From: [Butler, Steve](#)
To: [Hackenbracht, Jeff](#); [Saeed, Shirwan](#)
Subject: FW: Pages from PID 117607_FRA-161-15.80 Noise Walls_Stage 2_01-22-24_Markups.pdf
Date: Thursday, March 21, 2024 11:27:24 AM
Attachments: [image001.png](#)

Please see response in [Magenta](#) below.

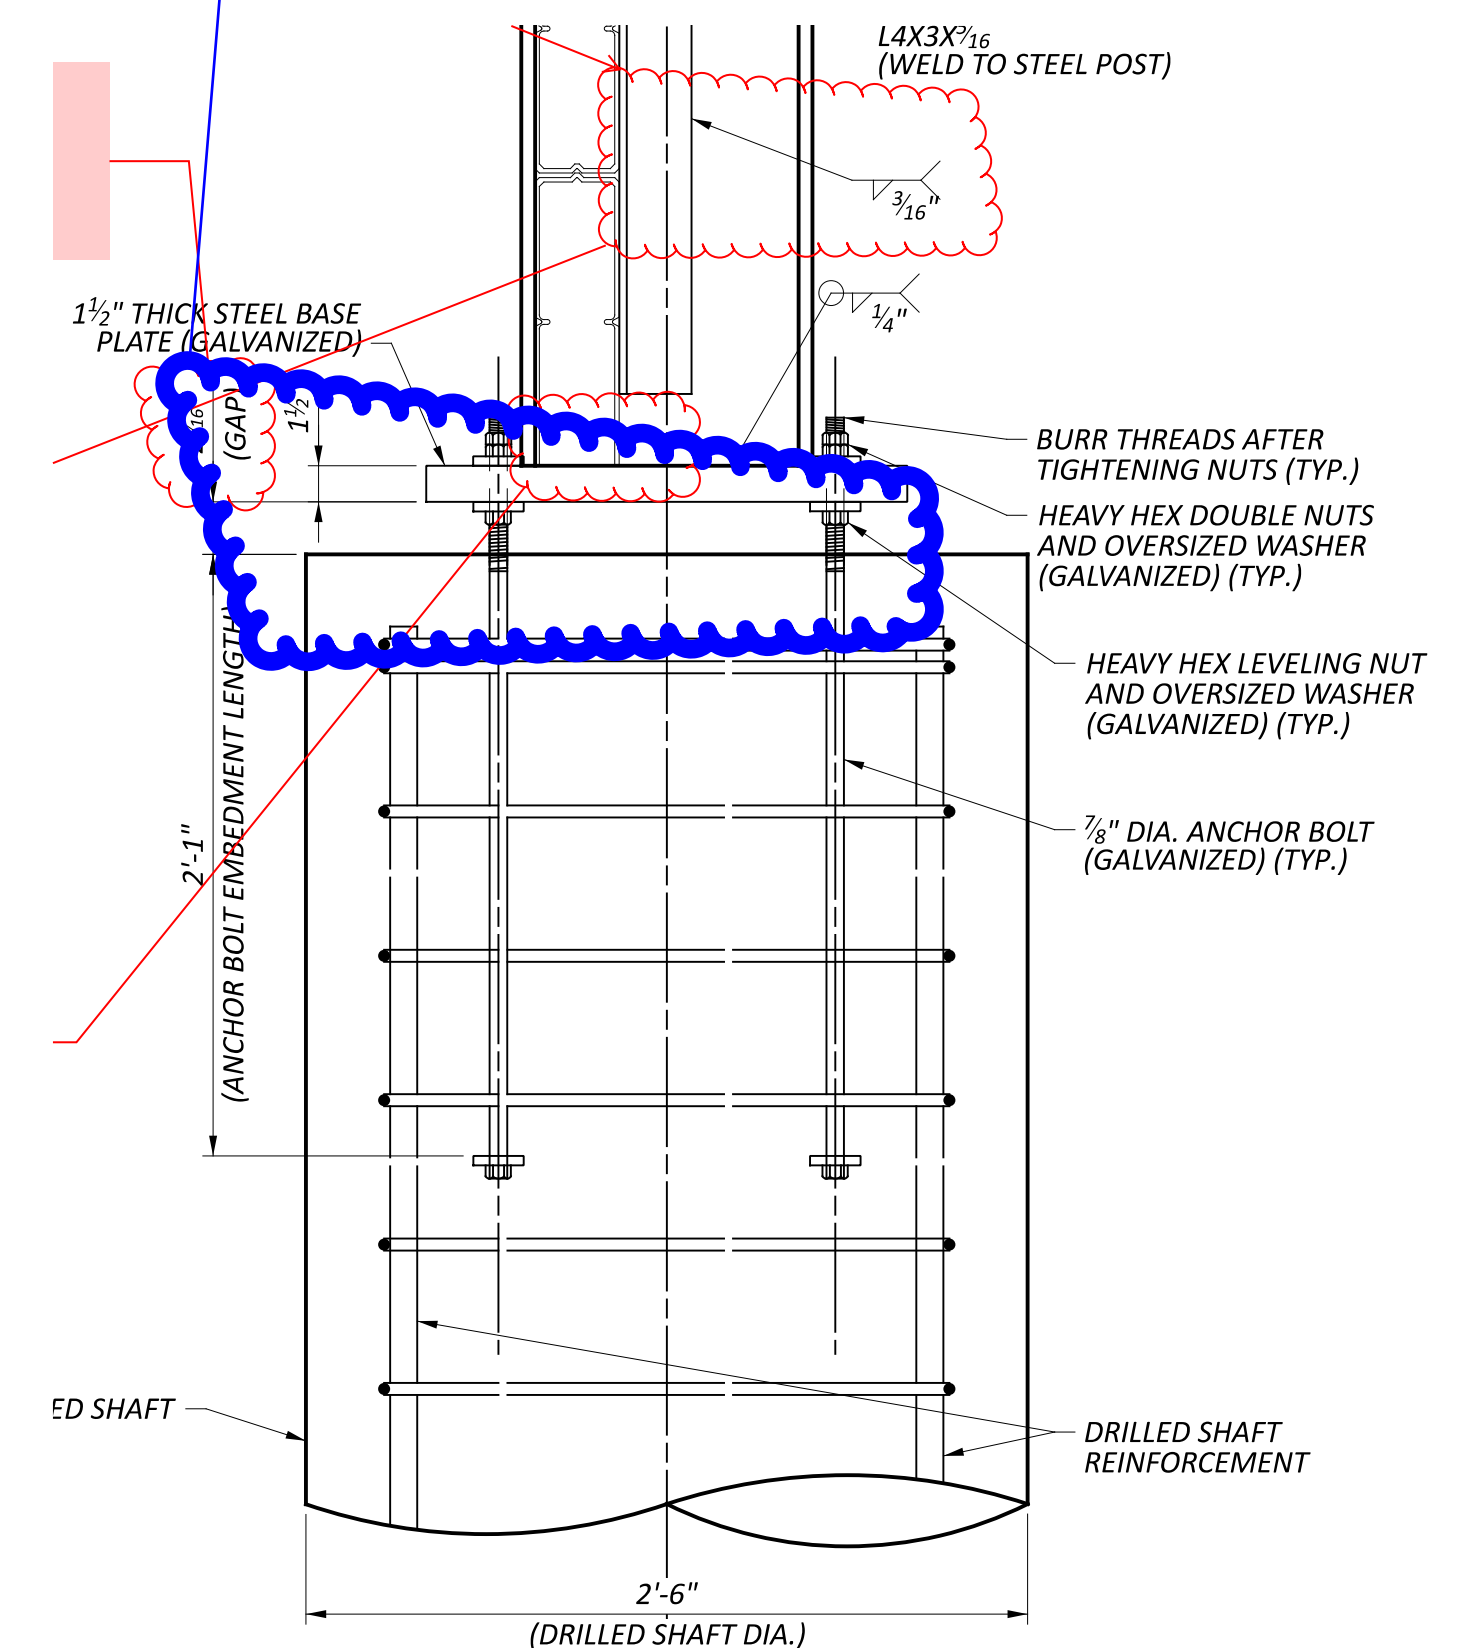
Arcadis Response: Complied.

Arcadis Response: Bearing pads are only required for the bottom panel supported on the baseplate and support angles. The note has been reworded for clarity.

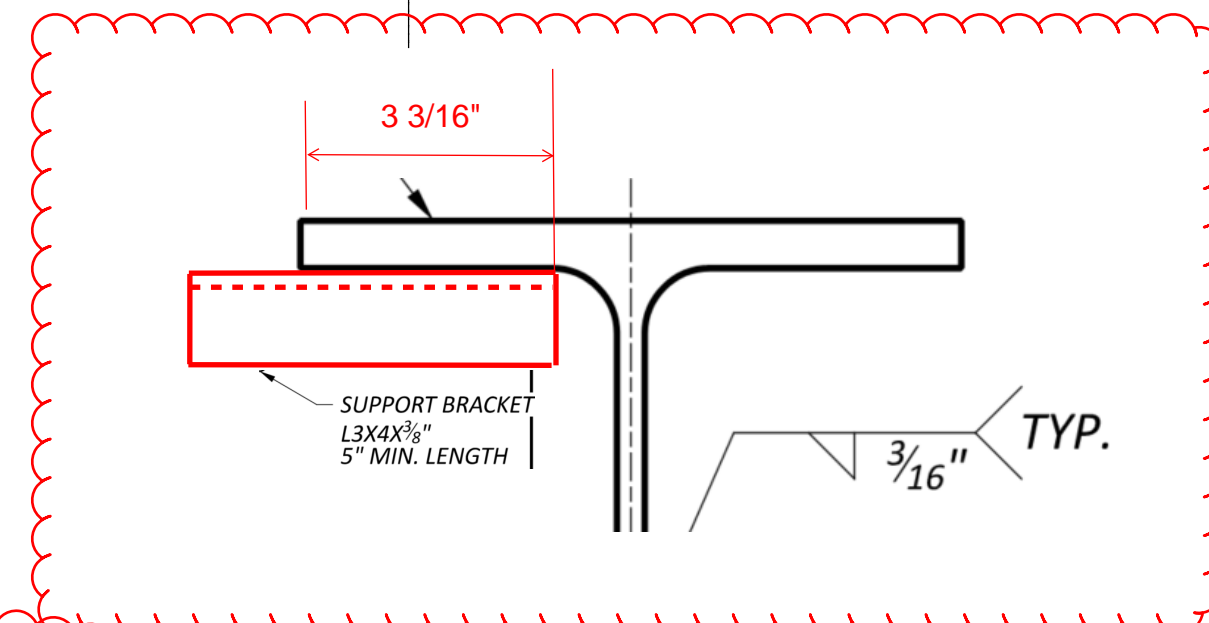
Arcadis Response: Panel and dimension have been added.

Arcadis Response: A second section has been added.

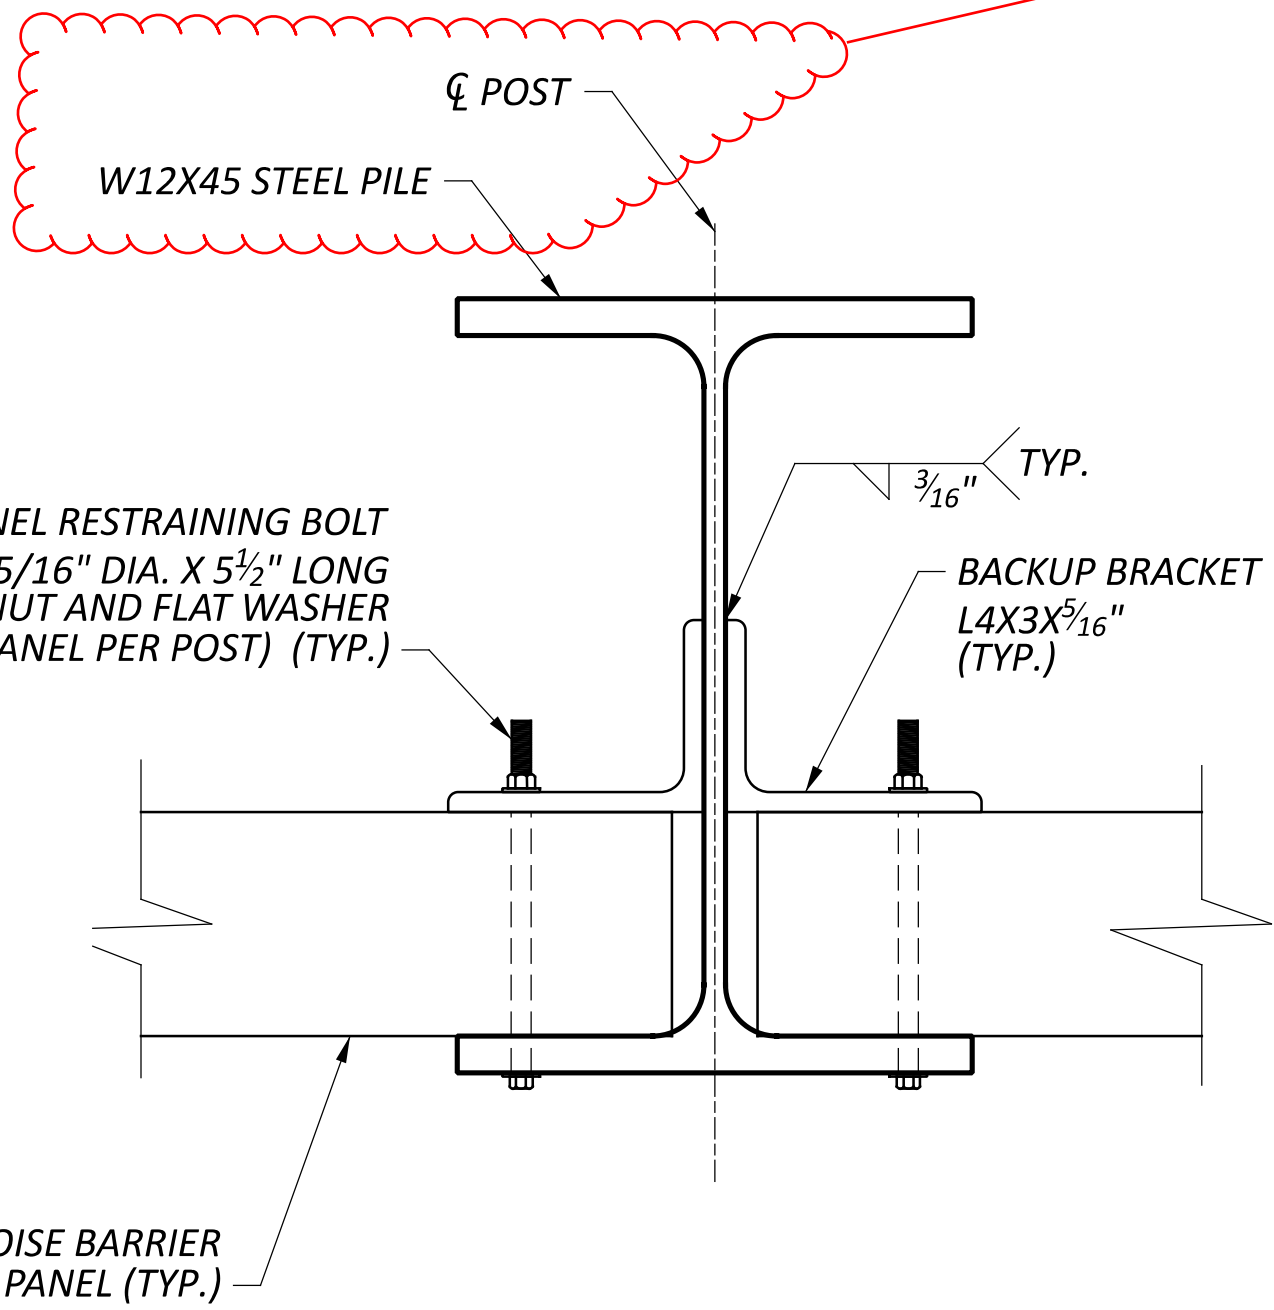
Detail sheet 2 of 3 calls the W12x45 "posts" recommend using the same nomenclature to prevent confusion
 Arcadis Response: Complied.

Arcadis Response: Upon further review, we do not believe that this clip is needed here and the detail has been modified accordingly.

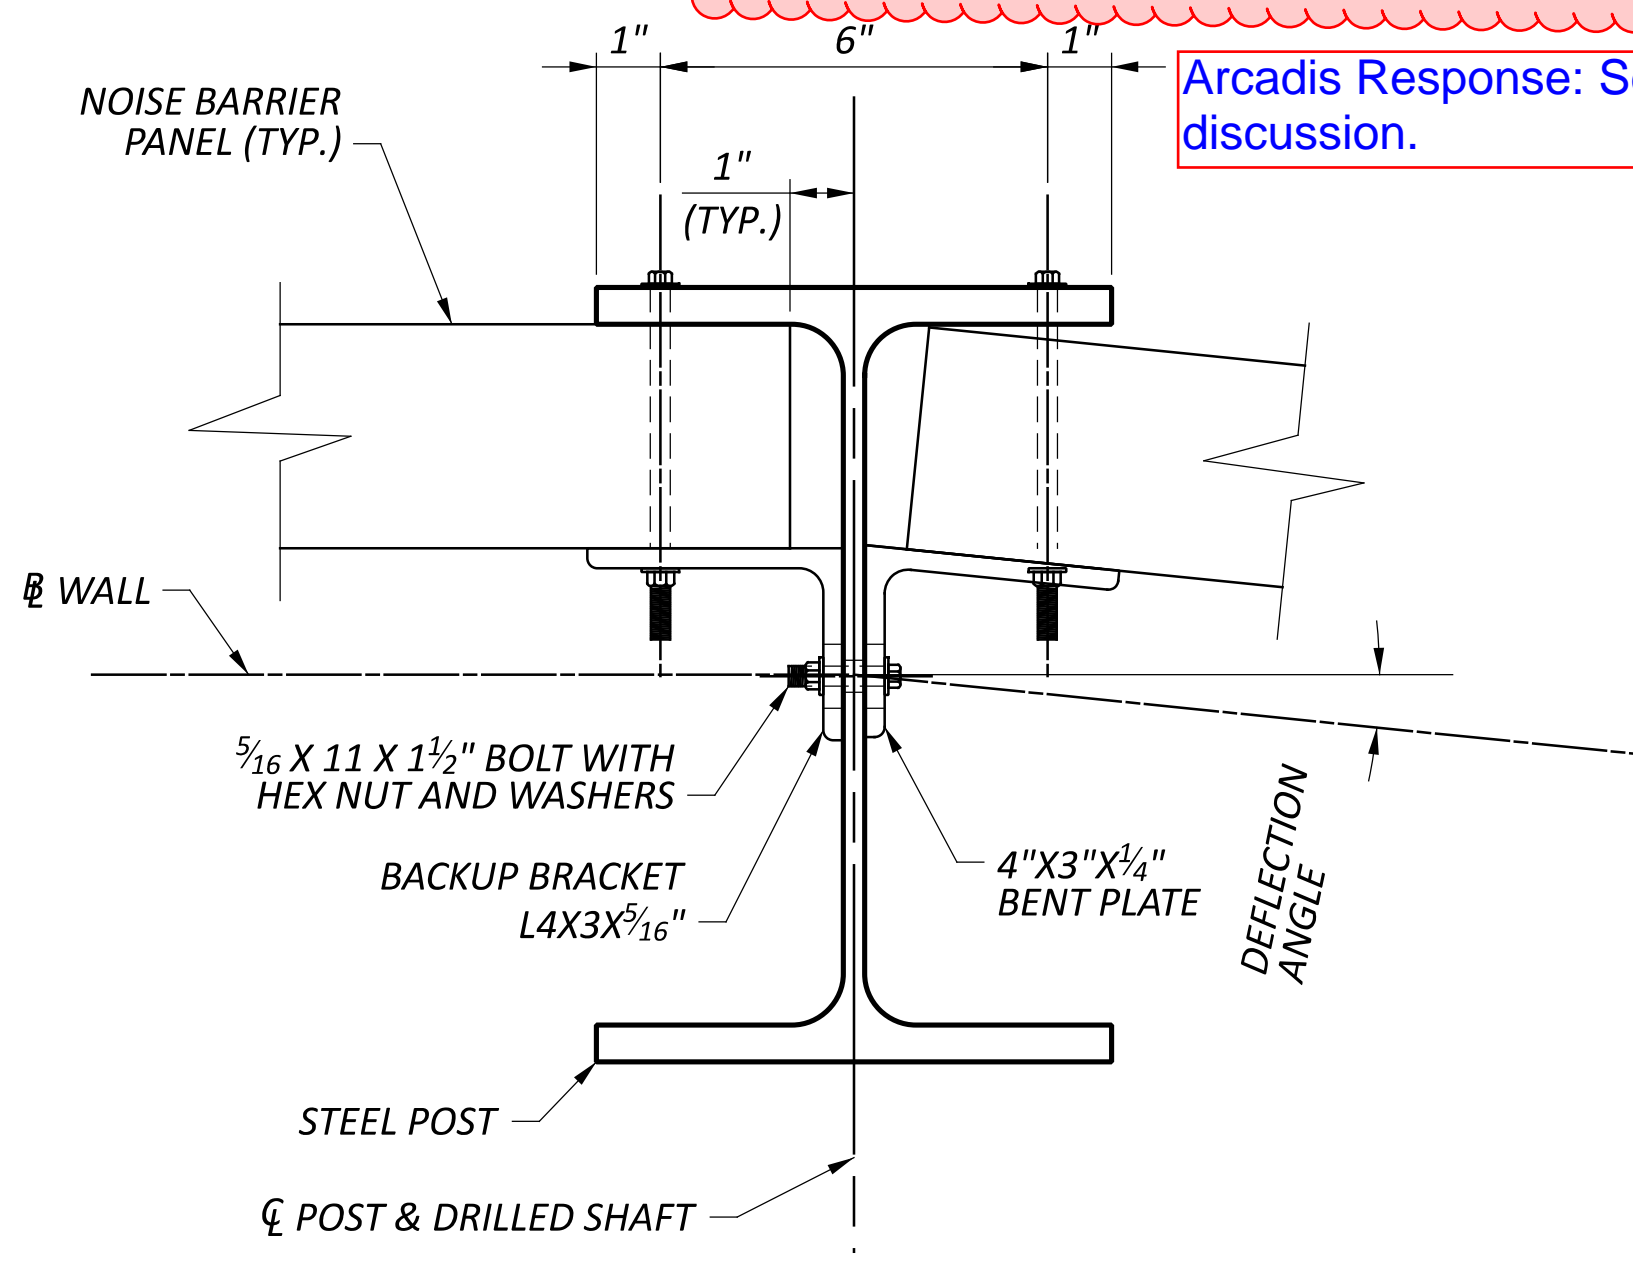
Arcadis Response: See email discussion.

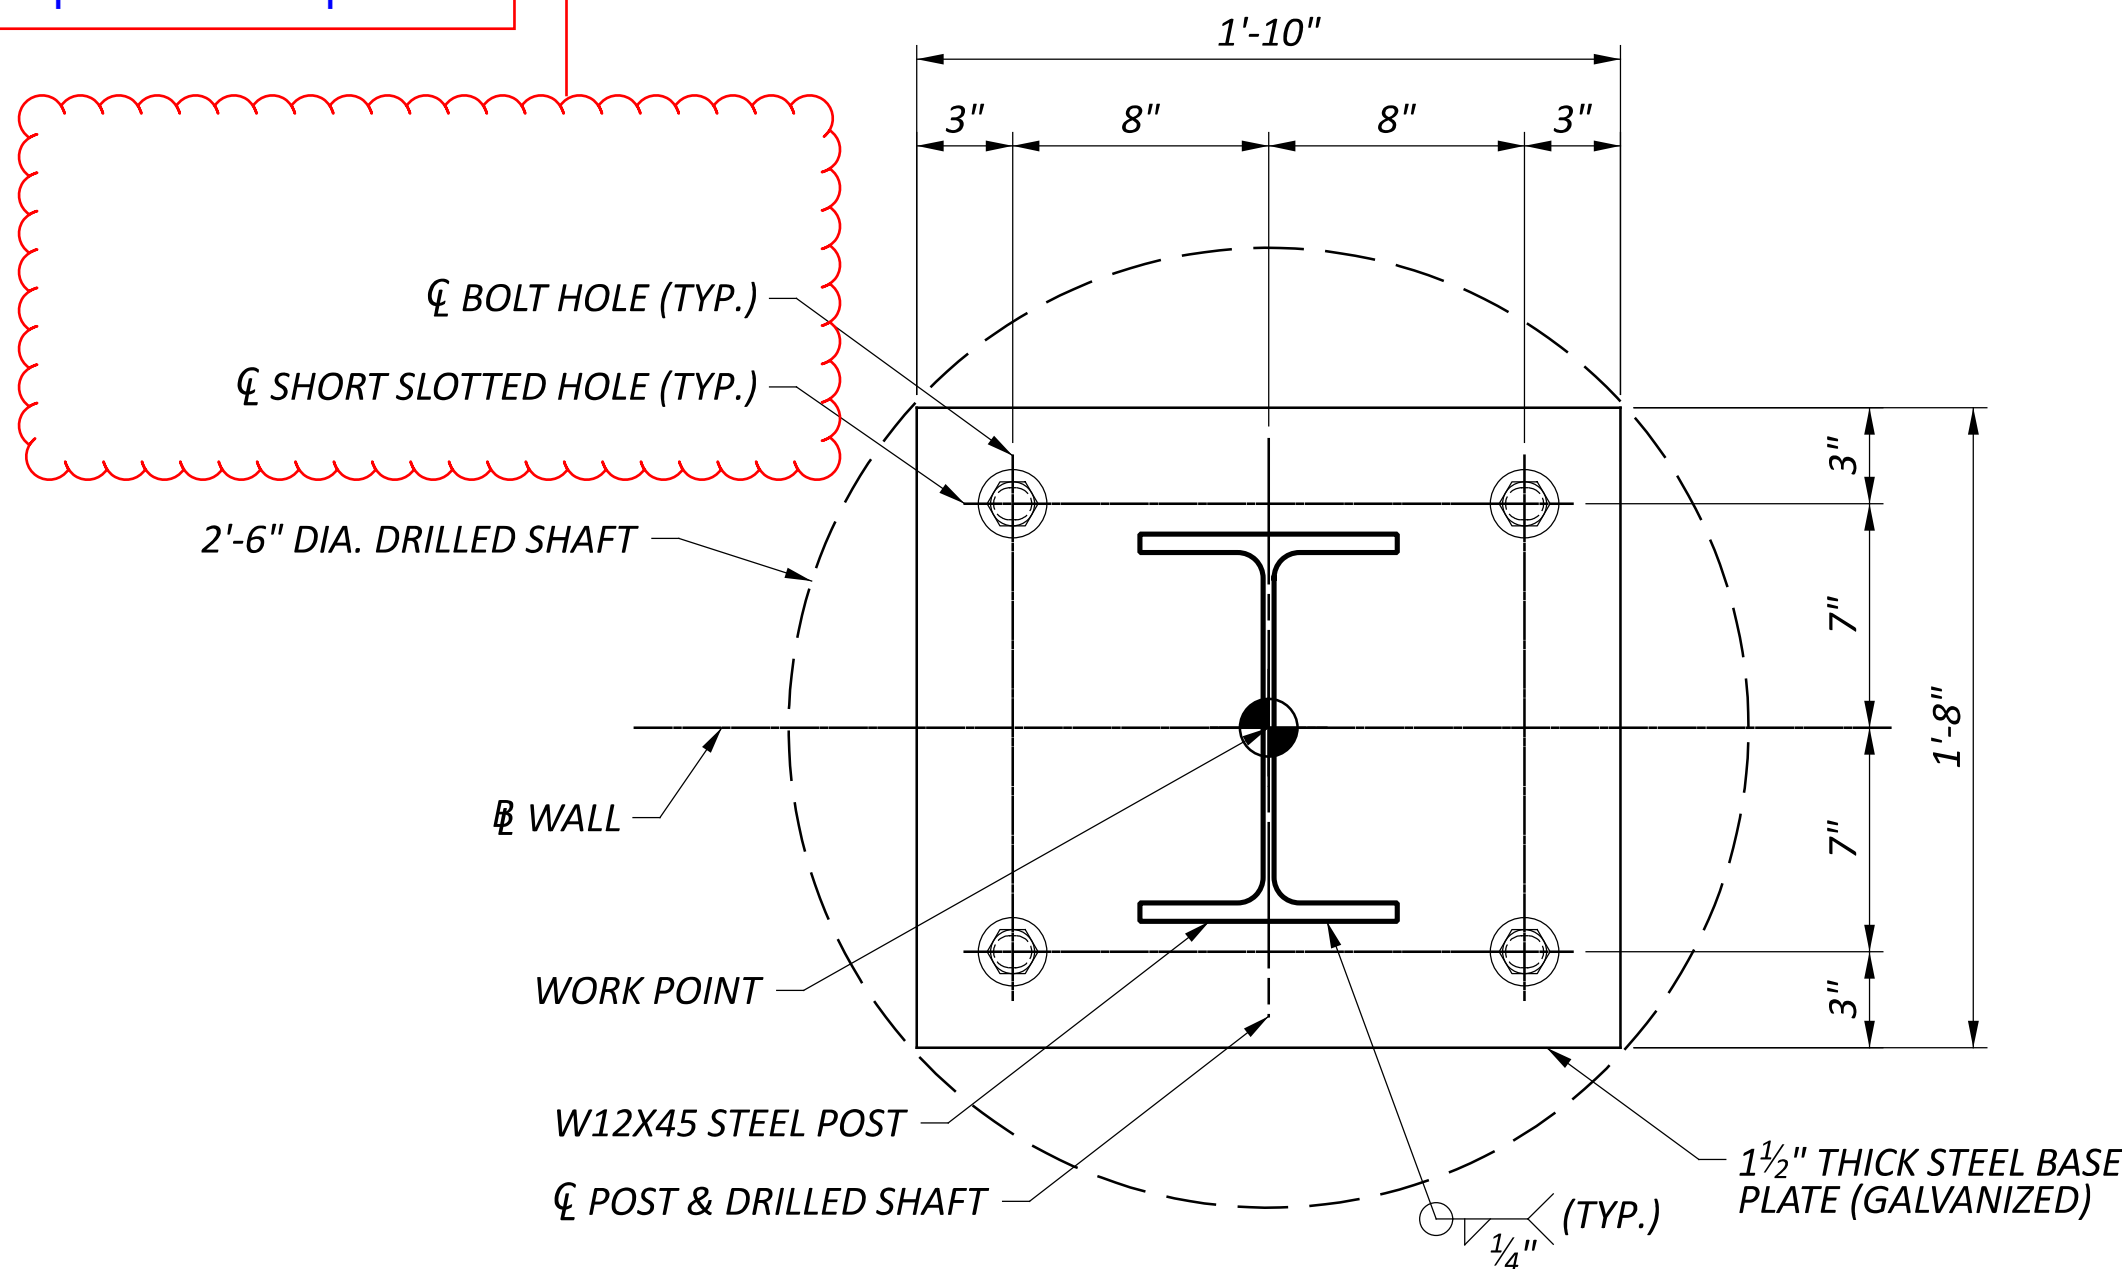
Arcadis Response: Complied.

Arcadis Response: This has been modified to the welded connection.
